CITY OF NEWARK
NEWARK WAREHOUSE #2 EXPANSION
ITB NO. 24-03

ADDENDUM 3
AUGUST 26, 2024

C-101

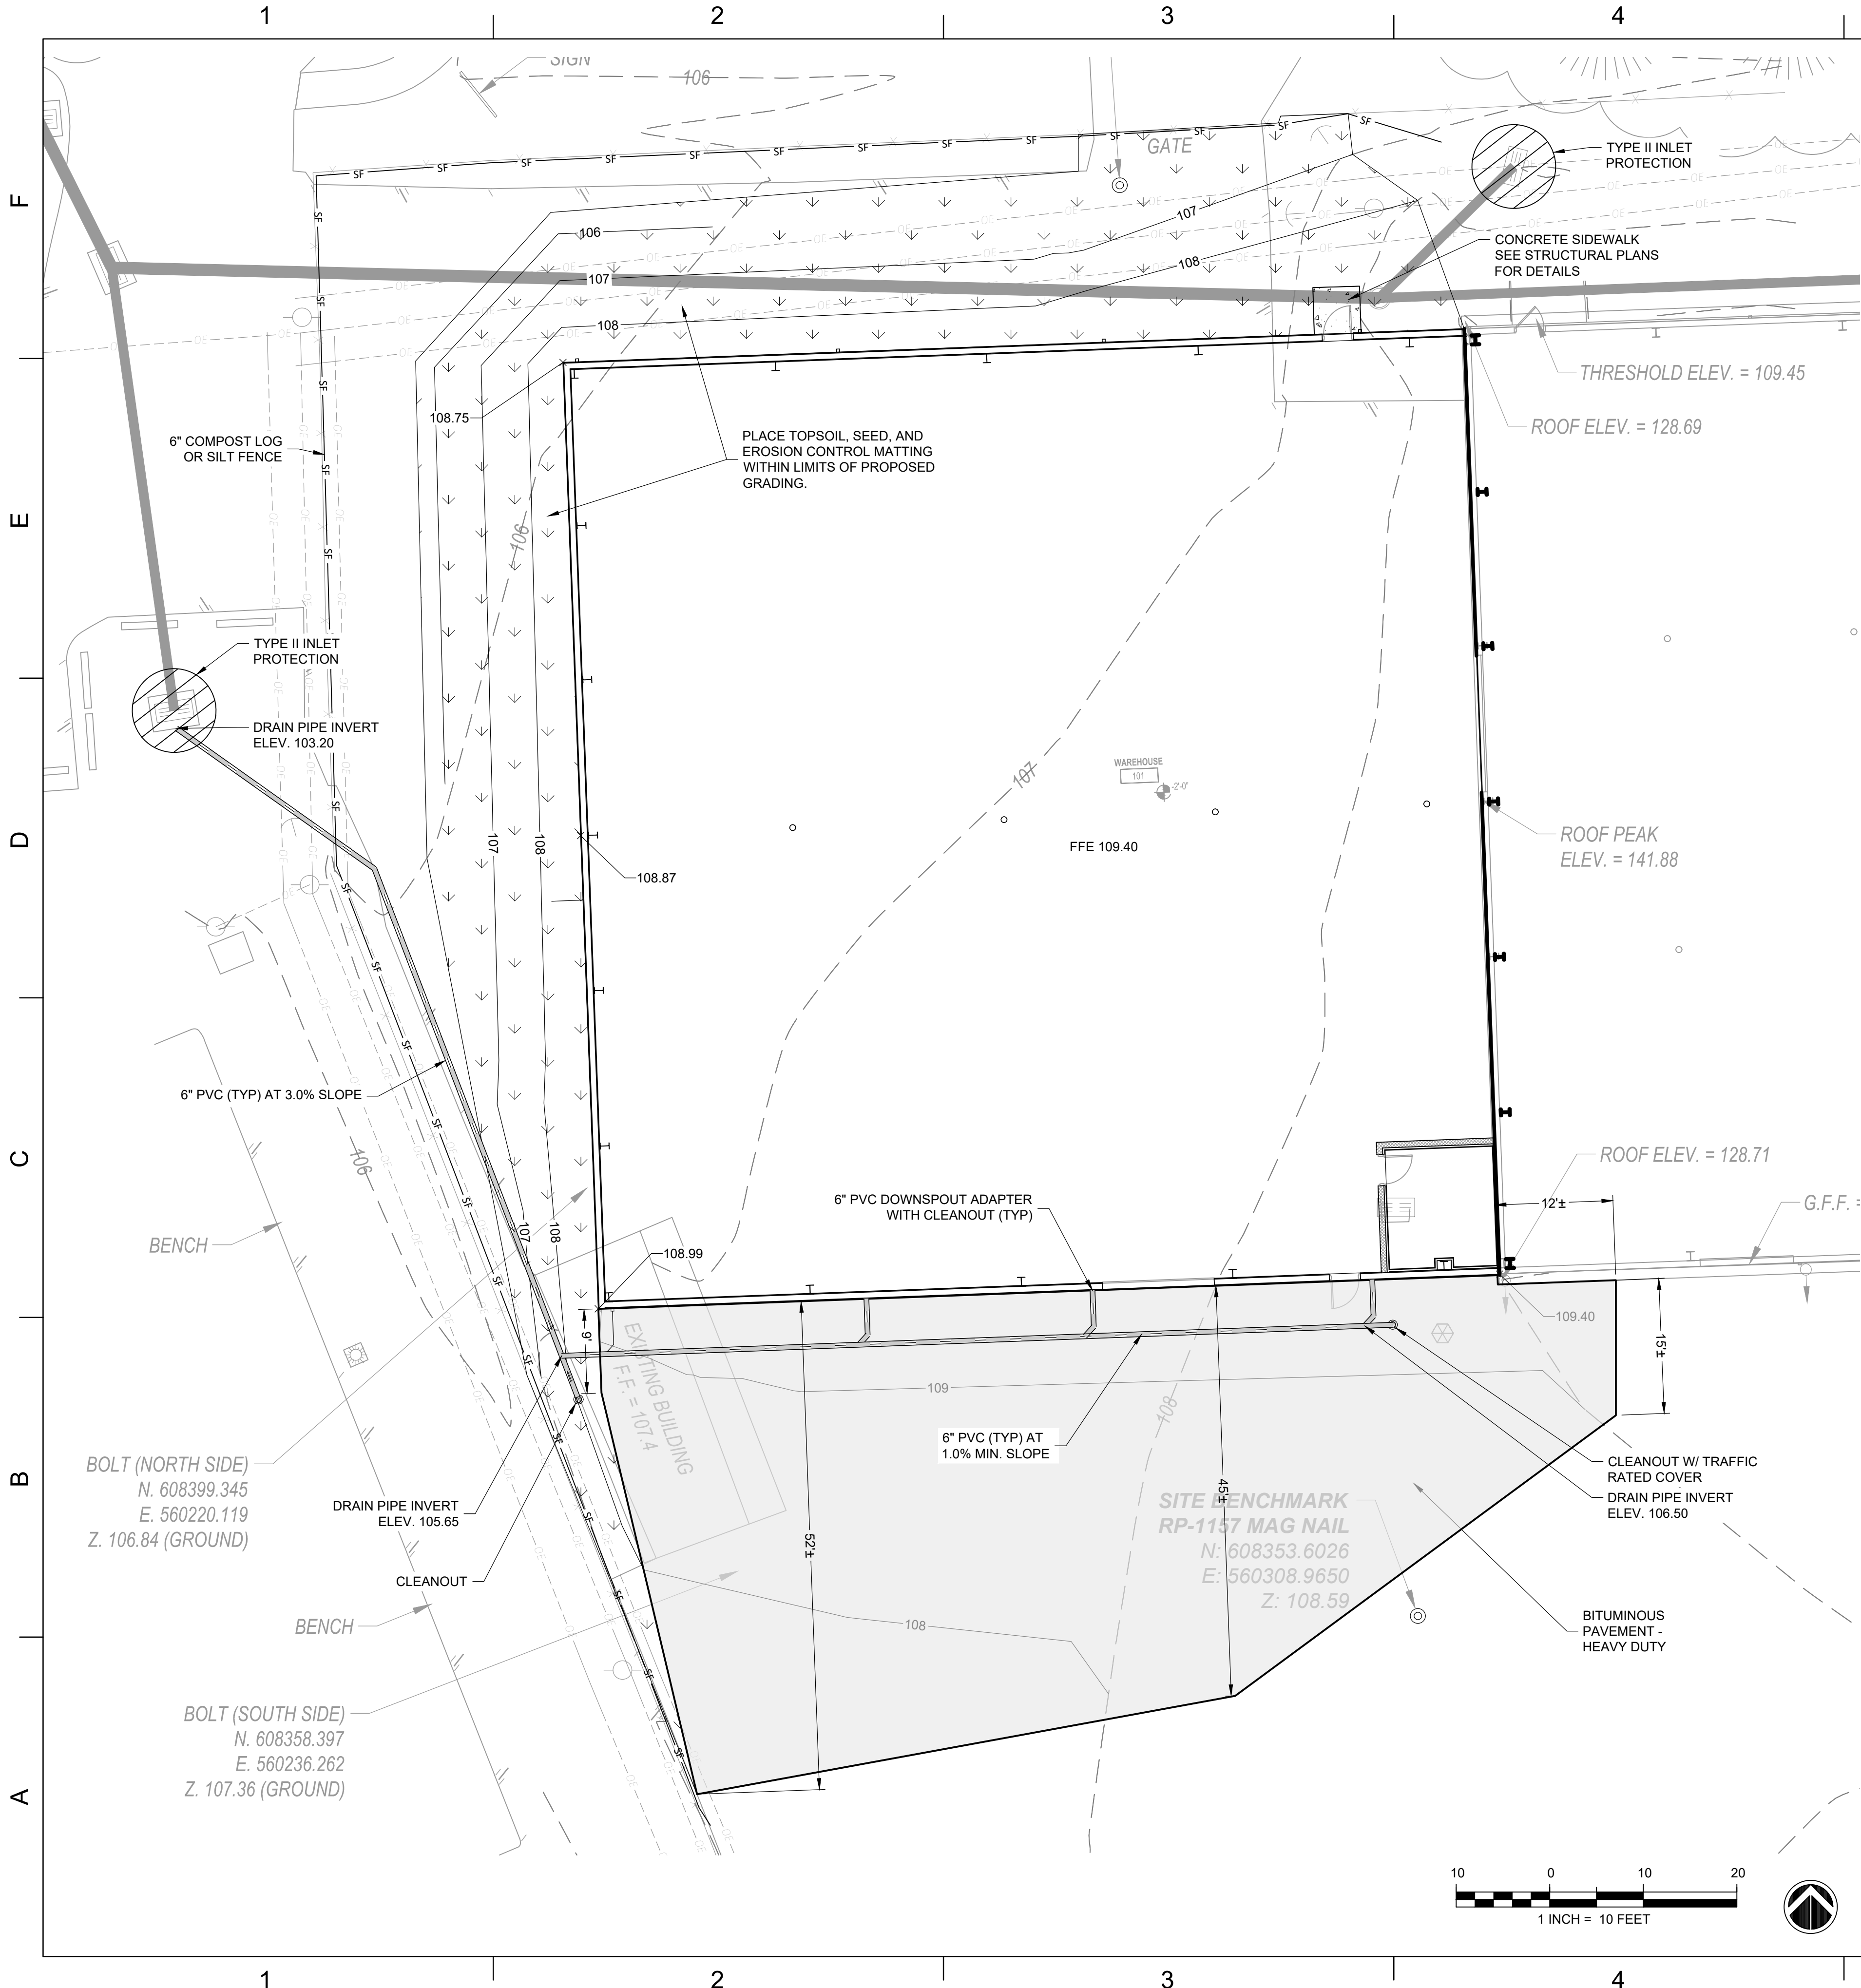
is the responsibility of the engineer to place these items on the contract drawings. Absent any erosion controls shown on the drawings, the owner should not expect any to be included in the bid. Please have the engineer place the appropriate erosion controls on the drawings, or specify the quantities required, or specify an allowance so all bidders are using the same quantities.

Response 2:	Sheet C-101 has been updated to include erosion and sediment control measures. However, the Contractor is still responsible for additional erosion and sediment control measures (such as a concrete washout) if this is needed based on their means and methods of construction. Please also note that the roof drain is now connected to an existing inlet.
